SUBJECT: Wake County; Division 5; US 64 from New Hope Road/
SR 2306 to Existing US 64 near SR 1003; Federal Aid No.
NHF-DPI-0199(004), State Project No. 8.1402202; TIP Project No.
R-2547

Re: Certification Pursuant to Section 401 of the Federal Clean Water Act,
 Proposed US 64 Bypass of Knightdale from I-440 (Raleigh Beltline) to existing US 64 near SR 1003, I-440
 from 0.83 miles south of US 64 to Poole Road and a portion of the East Wake Expressway from existing US
 64 to the proposed US 64 Bypass in Wake County (TIP R-2547).
 WQC Project No. 011689

NORTH CAROLINA 401 WATER QUALITY CERTIFICATION

SUBJECT: Action ID 200220819; TIP No. R-2547

PLAN VIEW

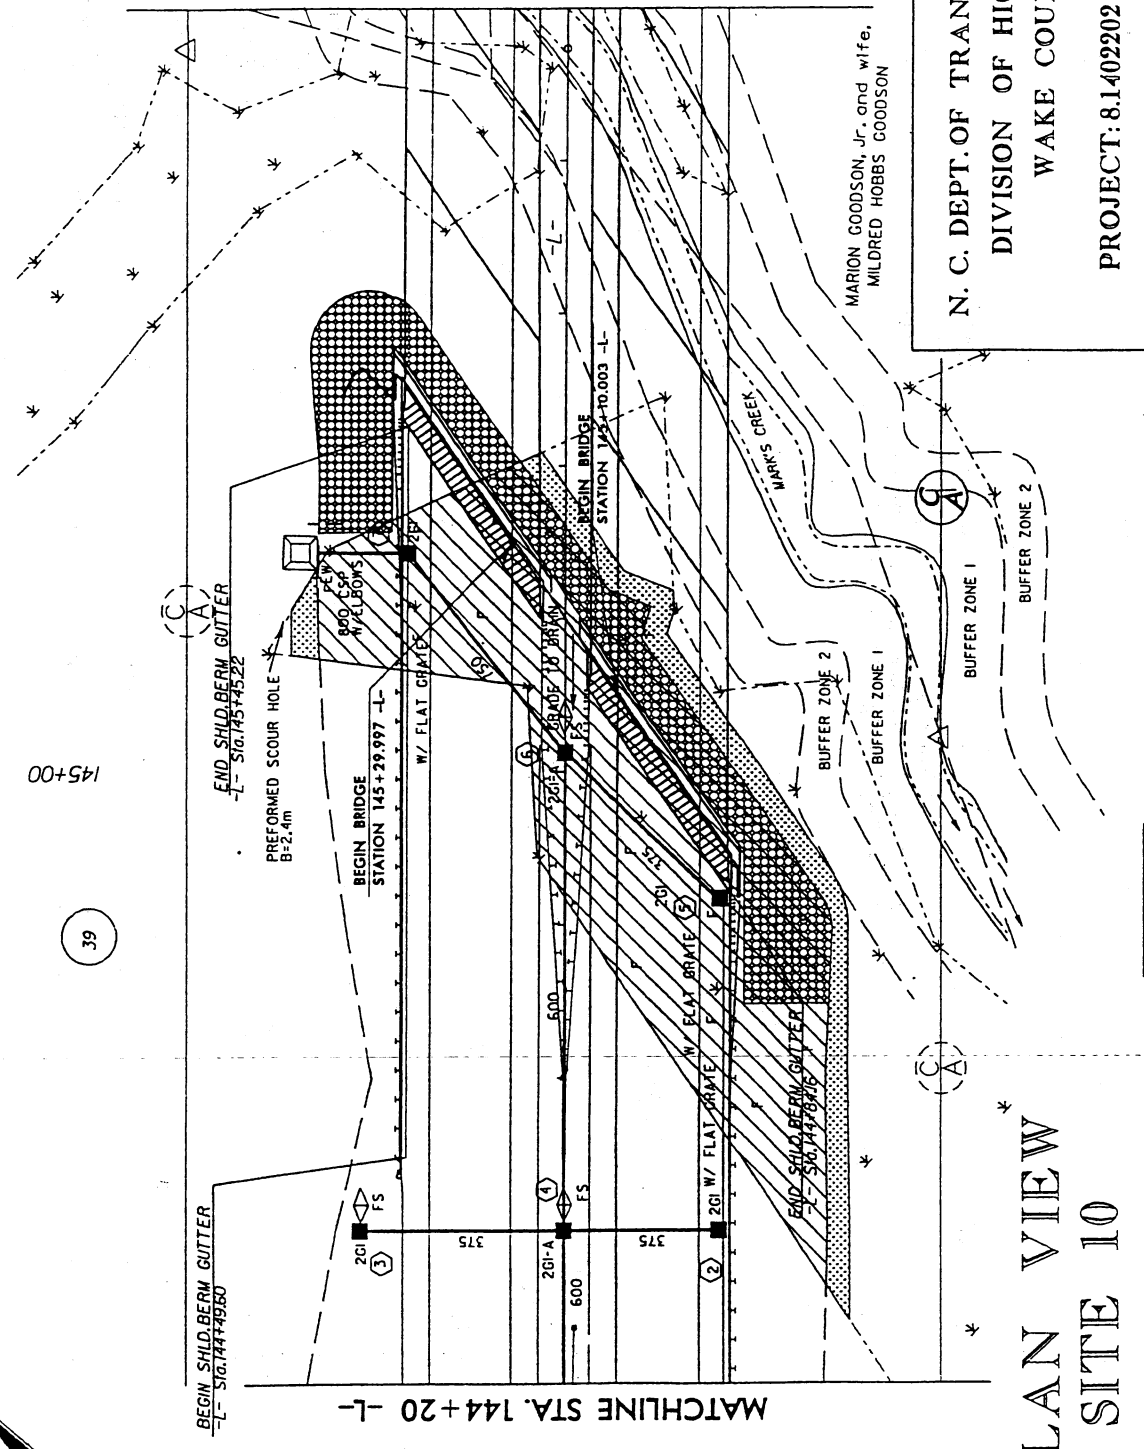
8. At Section CC, Site 9, the lateral base ditch located on the north side of Ramp CY1 shall be shortened in length to a point where it stops outside the protected riparian buffers. In addition, an appropriately designed flow spreader shall be added to the project design at this location. In lieu of a flow spreader, the NCDOT can submit to, and receive approval from, the NCDWQ appropriate information to demonstrate that the stormwater from the new impervious surface from this site will be treated in accordance with the Neuse River Riparian Buffer Rules (15A NCAC 2B .0233).
